NEW CHILD LOCK FUNCTION IN CRISS X USER INTERFACE

DESCRIPTION:

Placement of software label

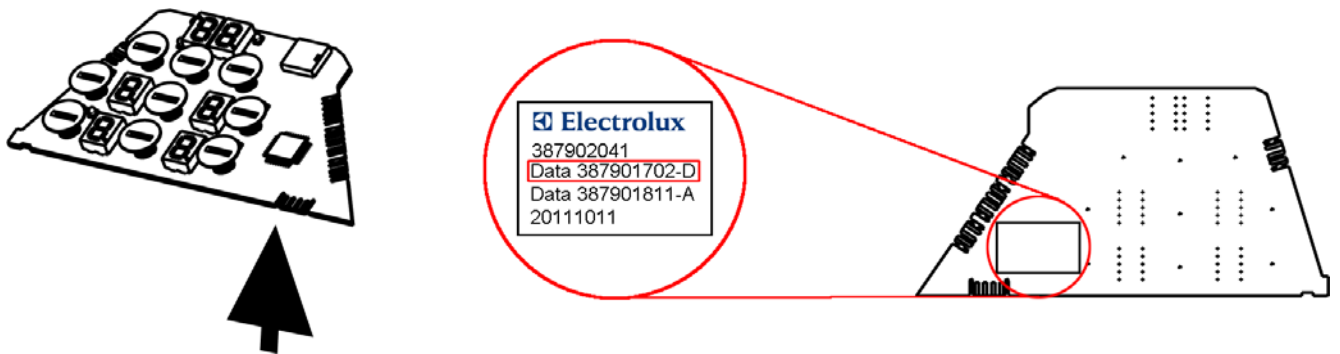
In currently active Criss X user interface boards, it is very easy to accidentally activate the child lock function. Because of that, there will be a change of software. As a result, child lock function will be activated and deactivated differently. This change is done on all boards with firmware **387901702-D** and higher. Refer to picture below on how to find the firmware version. This information is not relevant for all appliances which already run firmware 387901702-D or higher

IMPORTANT: After exchange of the user interface, instruct customer on new child lock activation/deactivation procedures
